SEWAGE DISPOSAL TESTING

STATE OF MARYLAND - DEPARTMENT OF HEALTH AND MENTAL HYGIENE

HOWARD COUNTY HEALTH DEPARTMENT
ENVIRONMENTAL HEALTH SERVICES

BLAISDELL PROPERTY

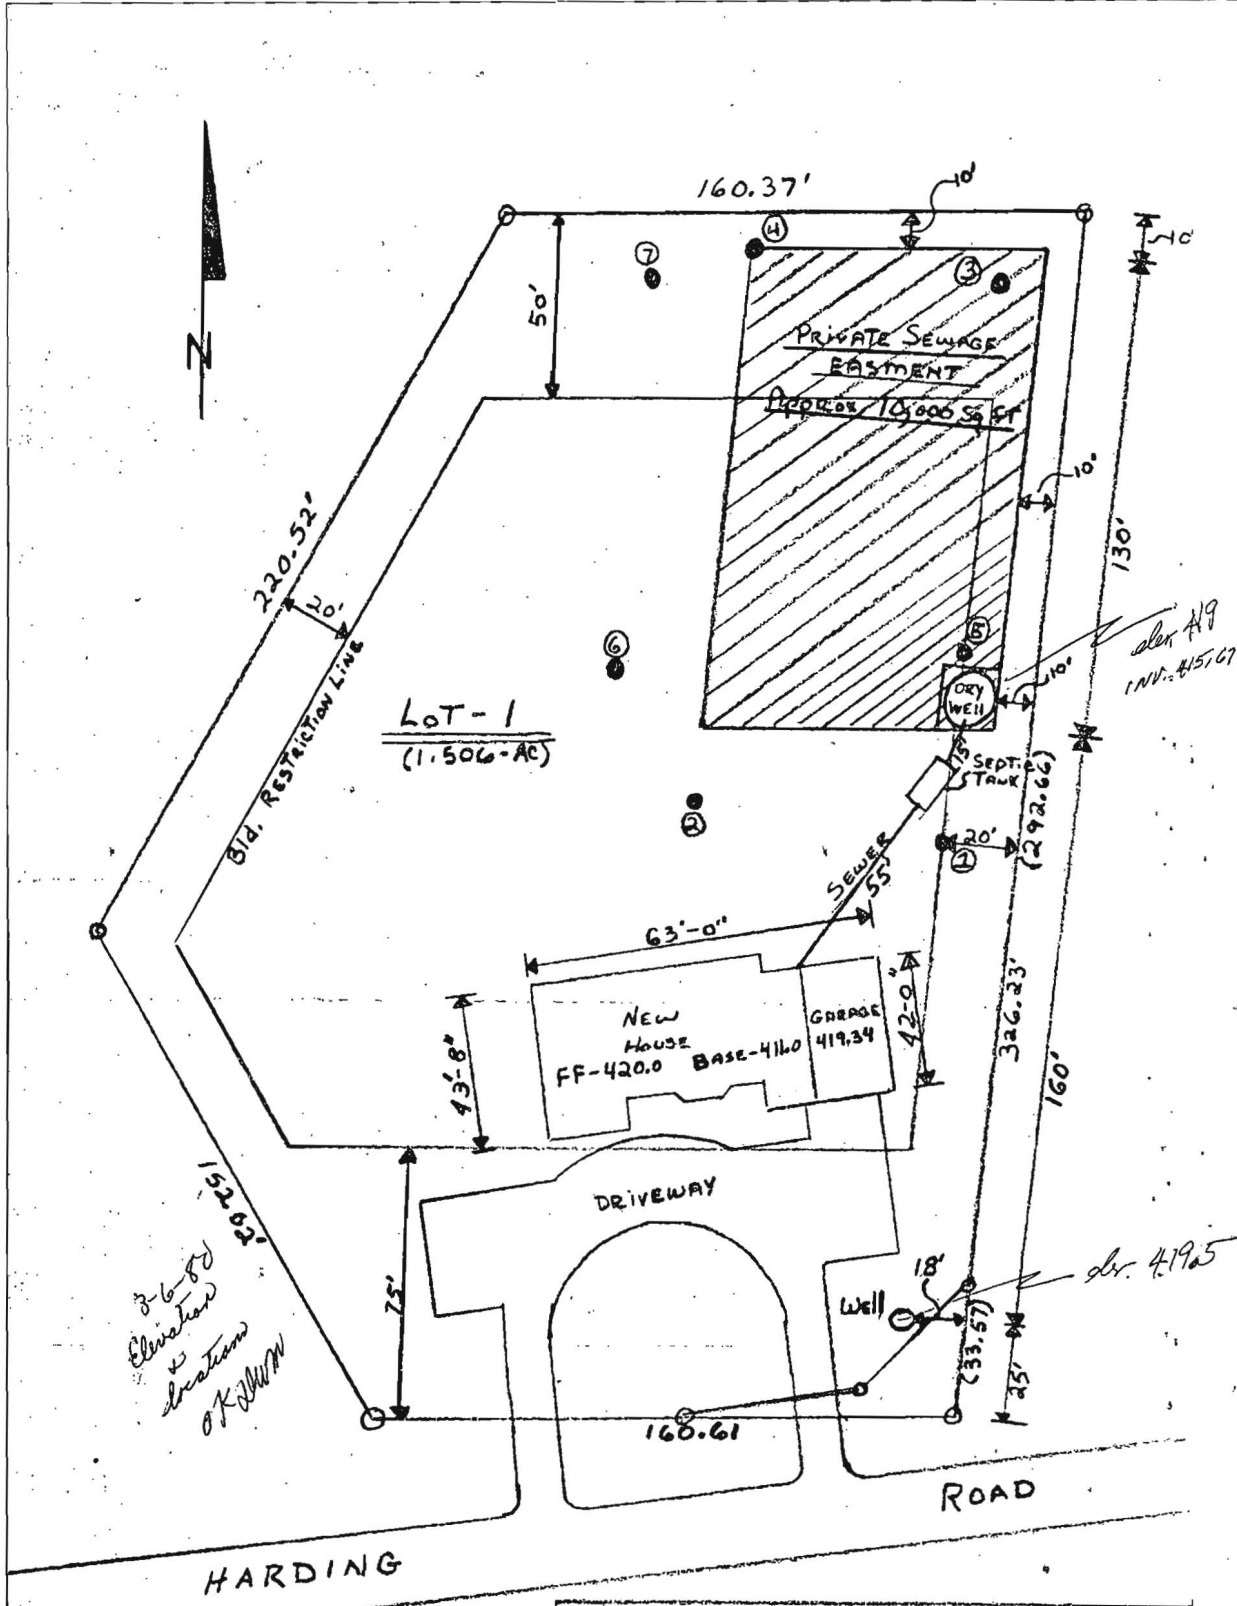
⊕ Dry well to have 125' depth effective absorption
sidewall area per bedroom
below first 5' of original soil. Inlet in at 4'
and maximum depth 12' below original grade.
location per engineer's plat: 20' off right
property line (and 175' from Harding Road when
facing lot from Harding Road
⊕ Dry well & trench used need:

(1) 5' earth buffer
between dry well
& trench

(2) 2 inspections
of trench before
and after stone

(3) Run trench with
contours of ground

9/29/78 Need holes certified & lot lines
certified - check for well & house location
also, e.r.d. 3/5/79 Discussed with F.F. & D.W.M.

PERCOLATION TESTS Good For
Holes 1,2,3,4,5

PERCOLATION TESTS unacceptable for
Holes 6,7
